DATE: 09/05/24
TO: All Bidders
FROM: David Cienfuegos, Purchasing Specialist
SUBJECT: Addendum 1 – Bid 685 Ventura College Admin Building Landscaping

A. Drawings L4.1 Landscape Renovation Plan:

SHEET TITLE
LANDSCAPE DETAILS
 PROJECT
 VENTURA COLLEGE
 ADMINISTRATION BUILDING
 LANDSCAPE RENOVATION
 4667 TELEGRAPH ROAD
 VENTURA, CA 93003

4 ROCK MULCH NTS

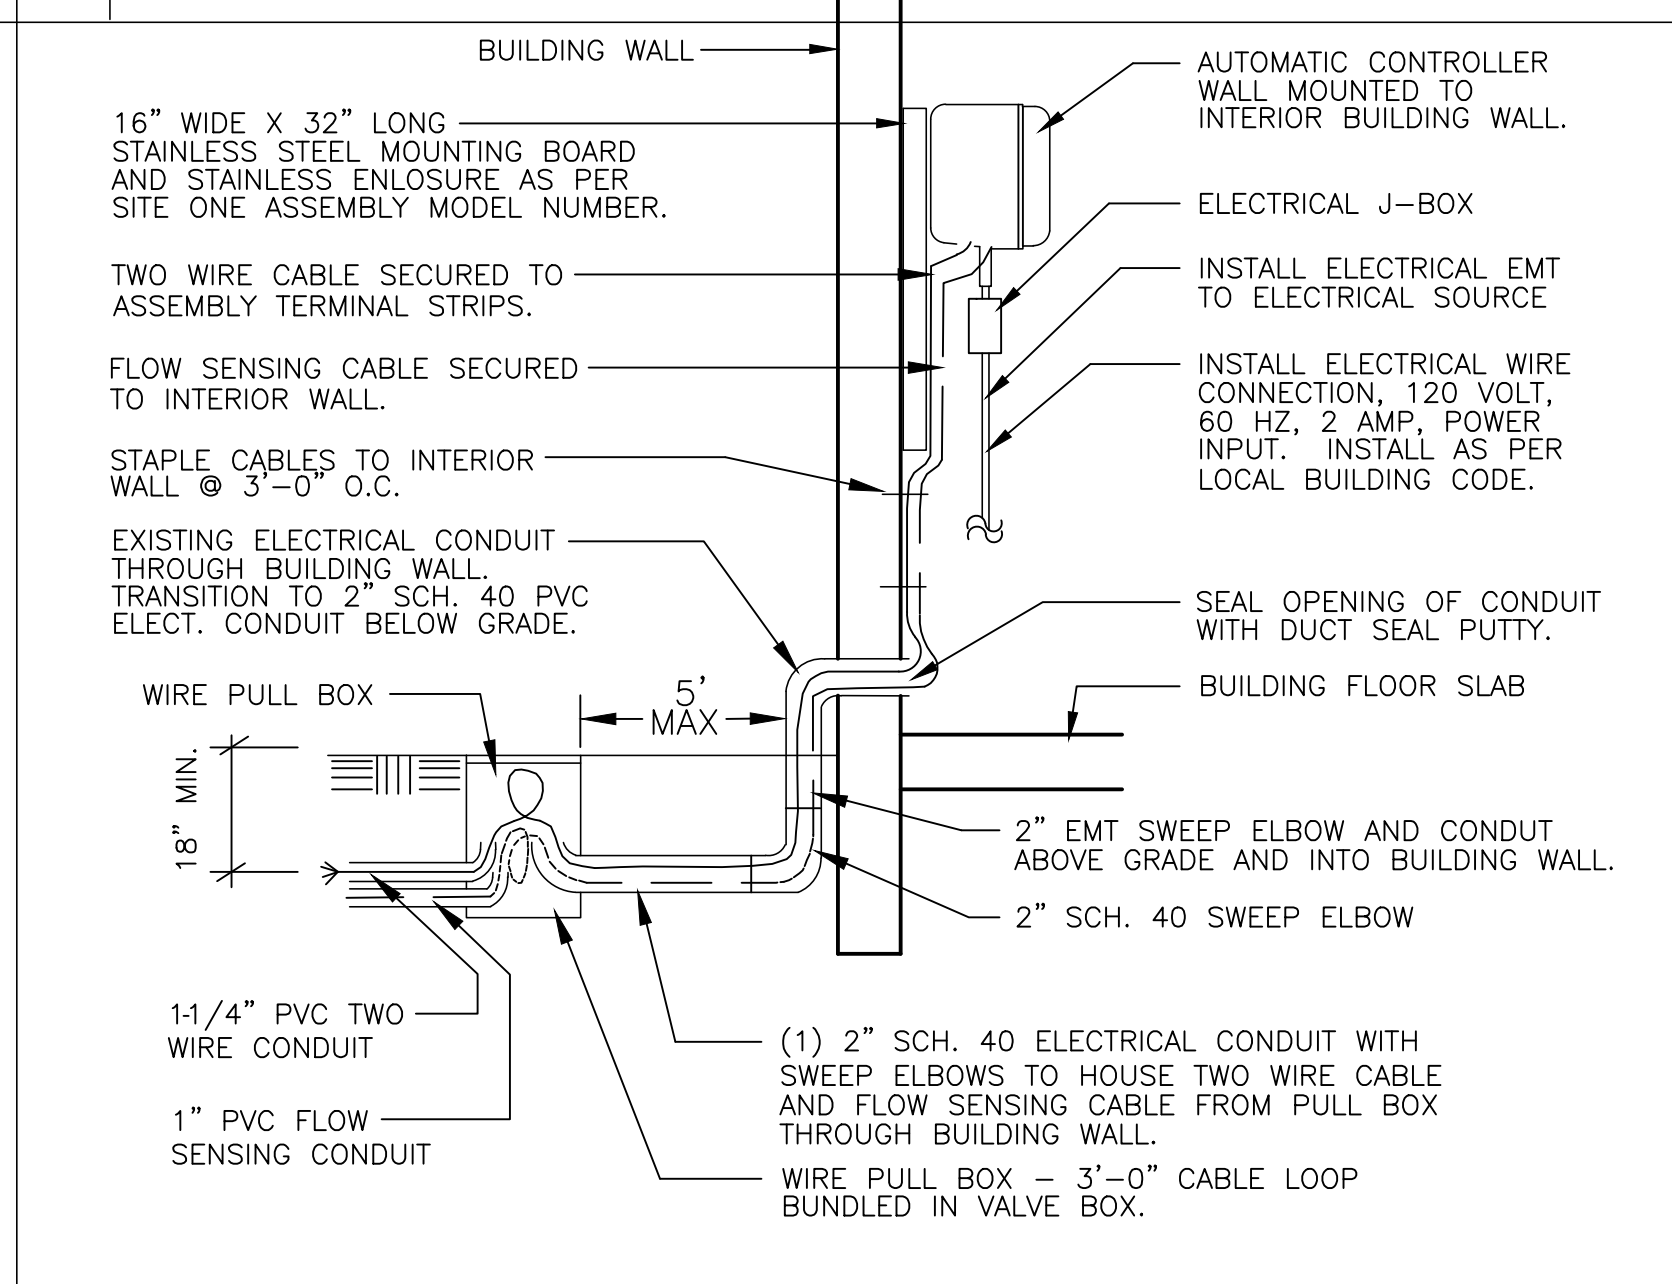
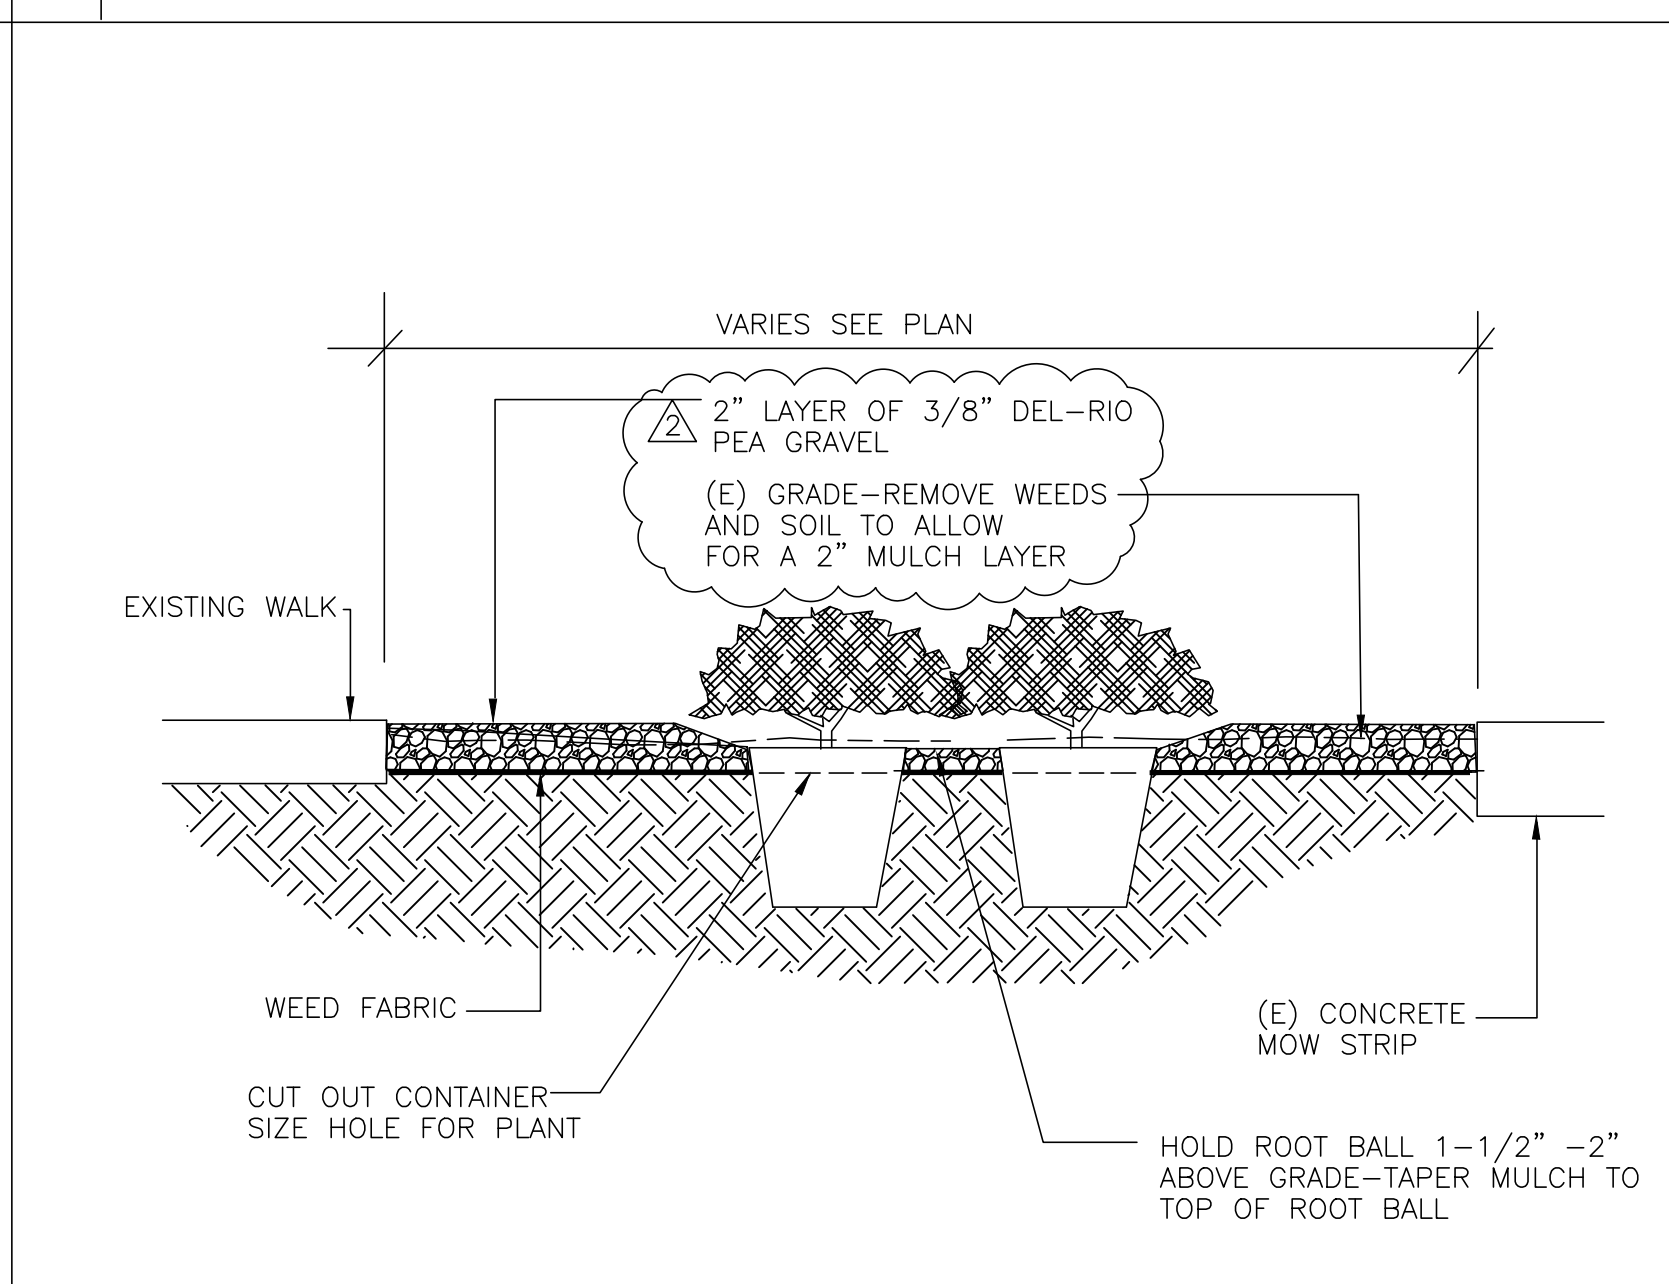
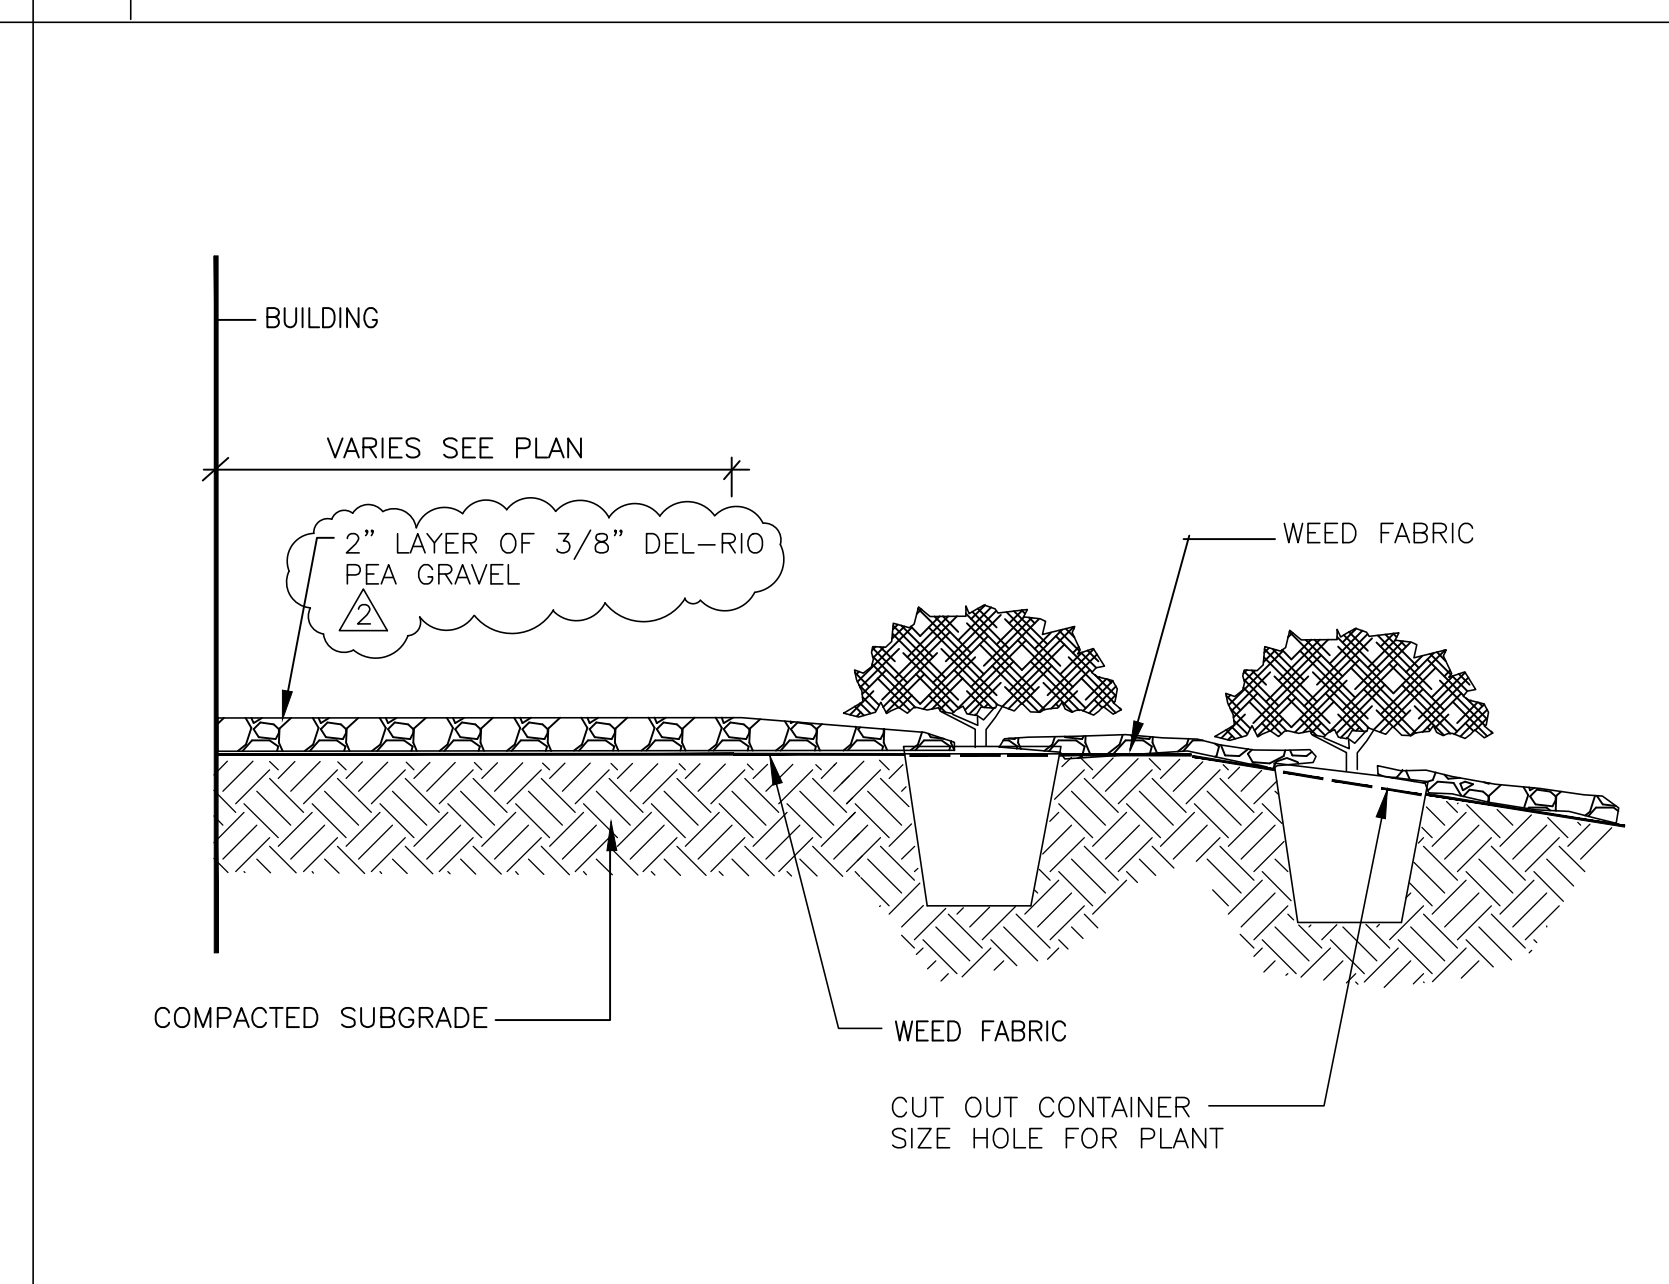
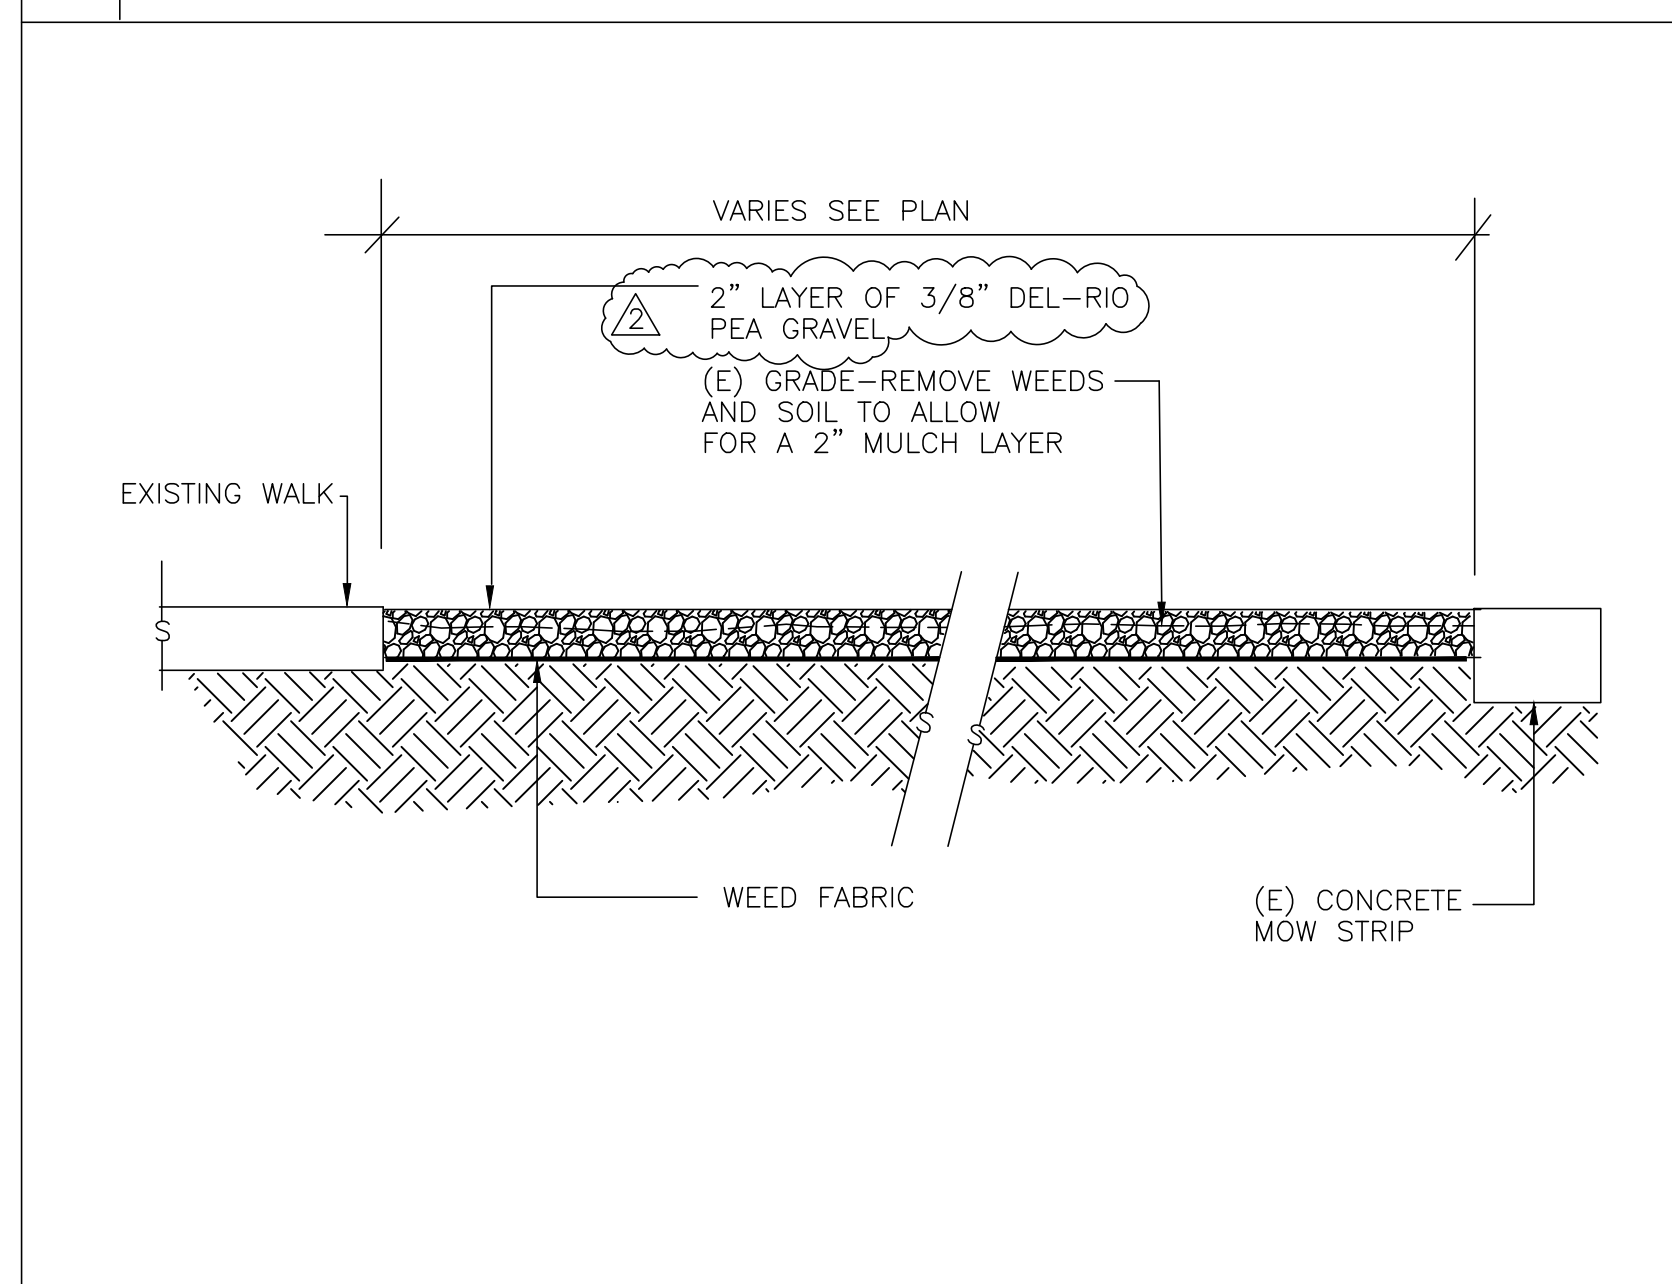
1. Details 1, 2, 3, 4, 5, 6, and 7 were clarified and show a two-inch layer of rock mulch.

1. Detail 4 Concrete Curb clarified with a two-inch layer of rock mulch.

1. Please provide the size for *Cycas revoluta* as shown on plant legend L4.1
 - a. See Addendum 1 Item A-1
2. Legend on sheet L4.1 shows 2-inch layer of pea gravel in planting areas. However, detail 3, 4, 5, 6, 7/L5.2 show 3" layer. Please clarify.
 - a. See Addendum 1 Item A-2 & Item B
3. Spec 329315-05/3.06 requires 2-inch layer of rock mulch throughout shrub areas where indicated on plan. However, detail 6/L5.2 shows black metal edging between rock mulch areas and shrub areas without mulch. Please clarify.
 - a. See Addendum 1 Item A-3
4. Detail 6/L5.2 requires ¼" x 5" black metal edging. However spec 329315-04/2.04 shows 1/8" x 4" black powder coated steel edging. Please clarify.
 - a. See Addendum 1 Item A-3 metal edge deleted.
